June 18, 1984

Joseph M. Farley Nuclear Plant - Unit 2
Response to NRC Questions - Reactor Vessel Surveillance
Capsule Report and Associated Technical Specification Change Request

NRC Staff Request for Information
Heatup/Cooldown Curves
Joseph M. Farley Nuclear Plant Unit 2

FIGURE 2 HEAD-TO-FLANGE WELD JOINT

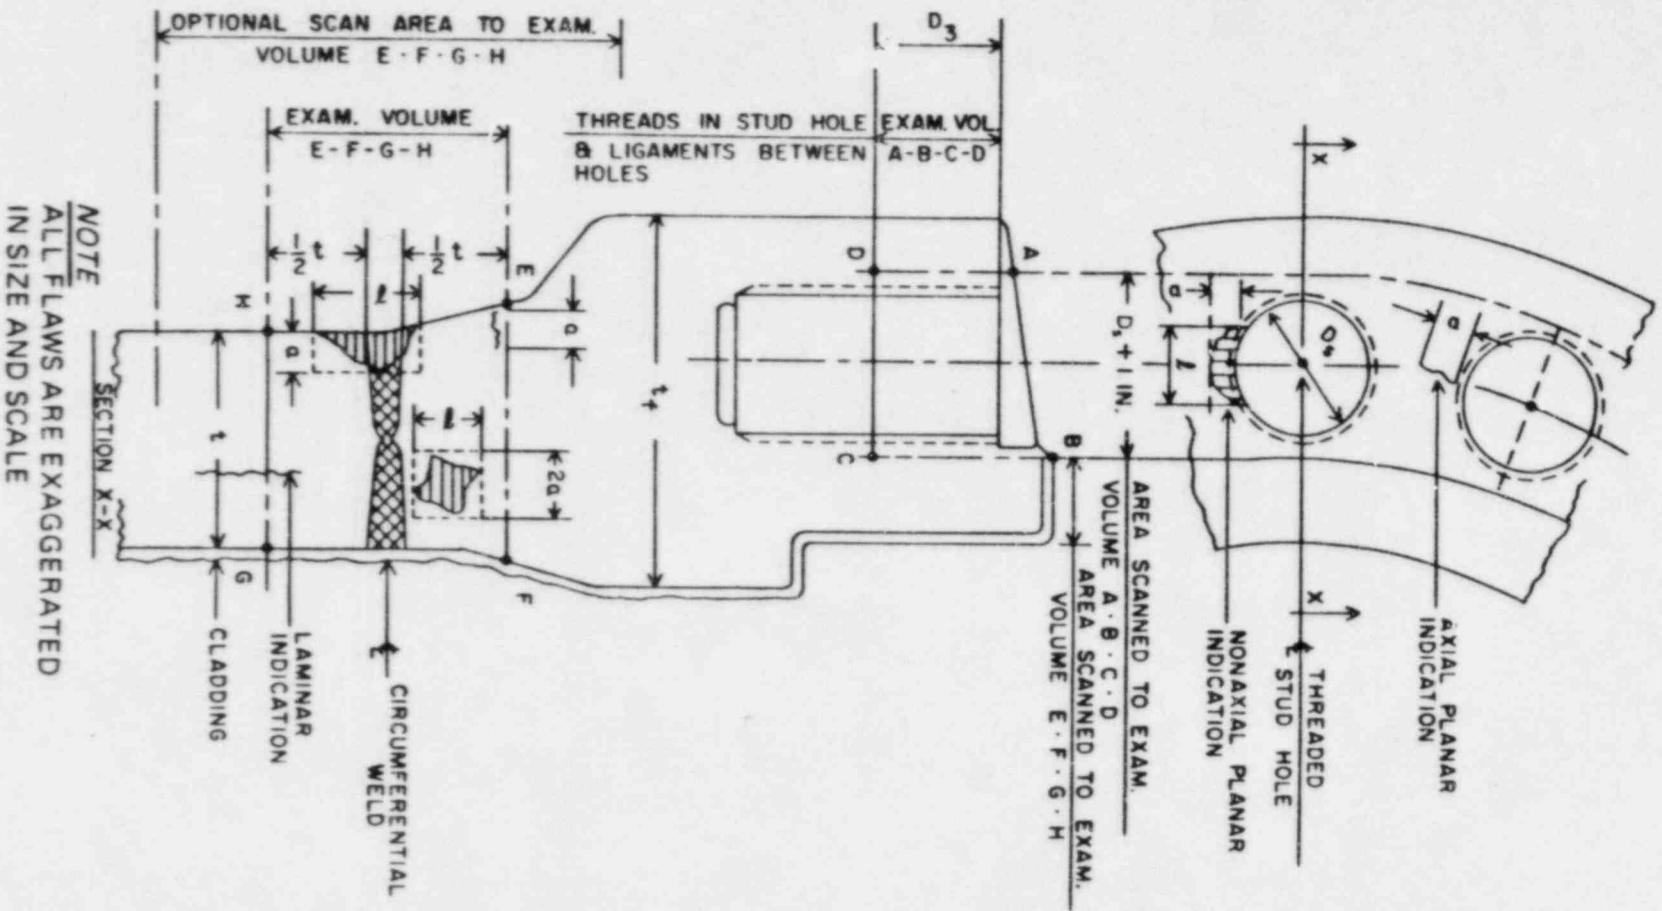
- f) Indicate the nondestructive examination methods that will be used during inservice examination to determine that the critical flaw size, which was used in determining the maximum applied stress intensity factors, is not within the flange to head and flange to shell junctions.

the boundaries for volumetric examination to include the weld and adjacent base material for a distance equal to one-half the weld thickness on both sides of the weld. The areas to be inspected are graphically represented in the Attached Figures 1 and 2.

Volumetric examination of the reactor flange-to-head weld and specified adjacent base material is accomplished by 0° , 45° and 60° refracted angle coverage from the head outside surface. Angle beam scanning is performed in two directions parallel to the weld and perpendicular to the weld from the dome side.
